Technical Bulletin

DP02	TB0041-2012	Elan Technologies	
From:	Billy Waits		
Subject:	THREE PIECE TAIL RELEASE	Date:	JAN 10th, 2012

Attention all Elan DP02 teams

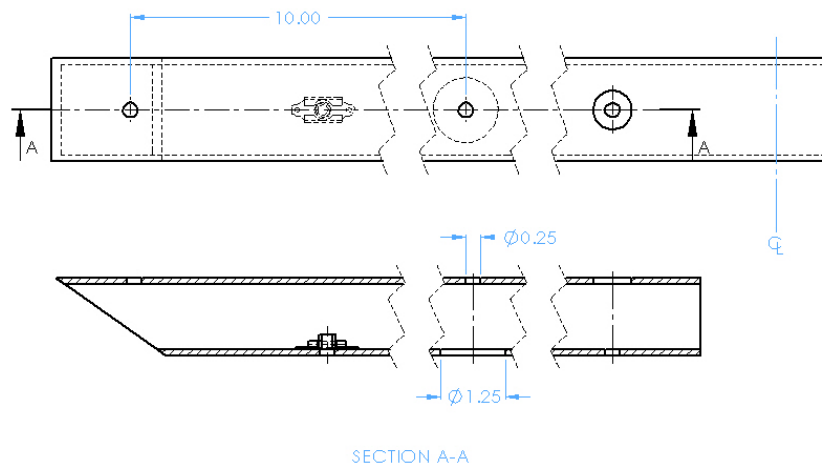
In response to team feedback, for 2012 we have released a split tail for the DP02 chassis. This new design allows for the mid section (engine cover) to be removed while leaving the two outer sections (fenders) attached to the chassis. The other objectives were to lessen replacement cost as well as shipping cost.

1. The split tail is a direct replacement fit and is manufactured to accept spring style cam locks.
 - a) During the installation it will be required to relocate two cam lock receptacles within the side pods (one left and one right of the engine cover) to fender joggles.
 - b) The optional tail support beam listed below has been updated to add two additional locations for nut plates in order to add additional fastening of the fenders to the beam. Alternatively, the current beam can be modified by the teams: On top side of the beam add two 1/4" diameter holes, 10" inboard from the existing tail mounting holes, On bottom of the beam add two 1-1/4" diameter holes, 10" inboard from the existing tail mounting holes. Either solution chosen will require to then back drill through the new holes into the fenders to locate the new fastening locations.

Part No.	Description	Qty Per Car
DP02-40-079	Split Tail, LHS	1
DP02-40-080	Split Tail, RHS	1
DP02-40-081	Engine Cover	1
DP02-40-022	Tail Support Beam, Updated	OPT
